Access Compliance Report

Public Rights-of-Way

(Curb Ramps)

Intersection ID: 14726	Main Street: REMOUNT_RD	Cross Street: S_TRYON_ST	Location: W
ADA ID: 623463773B70	Ramp Type: Perp	Initial Pass/Fail: Fail	Overall Compliance: No
Severity Score: 33.75			
Codes/Mitigation Info/Possible Solution		Field Measurements/Component Compliance

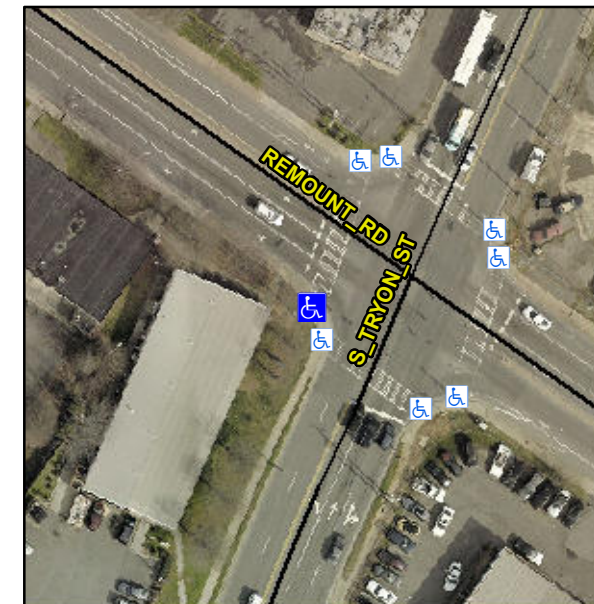
Not Found, R304.5.1, R304.2.2, R304.5.3

Compliance	Description	Data	Compliance	Description	Data
N/A	Ramp Length (in)	72.0	No	Ramp Slope (%)	10.8
No	Ramp Width (in)	47.5	No	Ramp XSlope (%)	6.1
N/A	Flare Type LT	N/A	N/A	Flare Type RT	N/A
N/A	Flare Slope LT (%)	N/A	N/A	Flare Slope RT (%)	N/A
N/A	Flare Traversable LT?	N/A	N/A	Flare Traversable RT?	N/A
N/A	Landing Length (in)	N/A	N/A	DWS Provided?	N/A
N/A	Landing Width (in)	N/A	N/A	DWS Contrast?	N/A
N/A	Landing Slope (%)	N/A	N/A	DWS Length (in)	N/A
N/A	Landing X Slope (%)	N/A	N/A	DWS Full Width?	N/A
N/A	Landing Curb? (Y/N)	N/A	N/A	DWS Offset (in)	N/A
N/A	Shared Landing?	N/A			
N/A	Gutter Ponding?	N/A	N/A	Gutter Slope (%)	N/A
N/A	Gutter Lip Ht (in)	N/A	N/A	Gutter X Slope (%)	N/A
N/A	Painted X Walk1?	Yes	N/A	Painted X Walk2?	N/A
	X Walk 1 Direction	To NE		X Walk 2 Direction	N/A
N/A	X Walk 1 Width (in)	114.0	N/A	X Walk 2 Width (in)	N/A
	X Walk 1 Slope (%)	7.8		X Walk 2 Slope (%)	N/A
	X Walk 1 X Slope (%)	4.0		X Walk 2 X Slope (%)	N/A

N/A	Ramp inside XWalk1?	Yes	N/A	Ramp inside XWalk2?	N/A
	Road Slope (%)	N/A	N/A	Clear Space?	N/A
	Road X Slope (%)	N/A	N/A	Clear Space to XWalk (in)	N/A
N/A	Any Obstructions?	N/A	N/A	Storm Grate/Utility Hazard?	N/A
	Obstruction Type			Storm Grate/Utility Type	
		N/A			N/A
		Yes		Surface Condition? (G/P)	Good

Possible Solutions:

Remove & Replace Entire Ramp.
